**Re: Hydro 2000 Inc. (Hydro 2000)
Application for 2020 Electricity Distribution Rates
Ontario Energy Board File Number: EB-2019-0041**

**H2000 Response to OEB Staff and VECC Interrogatories
2020 Electricity Distribution Rates Application
Hydro 2000 Inc. (Hydro 2000)
EB-2019-0041
June 12, 2020**

Ref: Exhibit 1, pages 42-43; 2018 Yearbook for Electricity Distributors

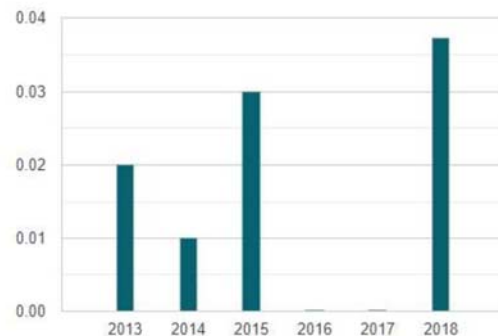
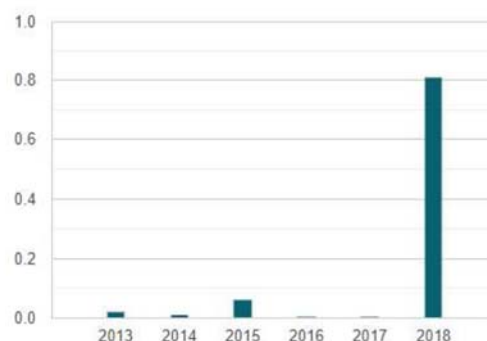
- a) Please provide the reasons why 2018 performance gets worse as compared to the prior years.

H2000 Response: H2000' 2018 performance was materially impacted by 2 adverse weather events. First, in April 2018, H2000's franchise area was hit with an ice storm that had an adverse effect on the supply of electricity from HONI. This incident took 22 hours to be restored completely and affected 25% of our customers. Second, in September 2018, the Ottawa-Gatineau area was hit by tornadoes declared to be one of the ten most significant weather events of 2018 in Canada. As a result of this weather event, a distribution pole in the village of Alfred fell over, breaking the top of another distribution pole. This event affected 30 of H2000s customers (2.3% of H2000's customers) for 5.75 hours.
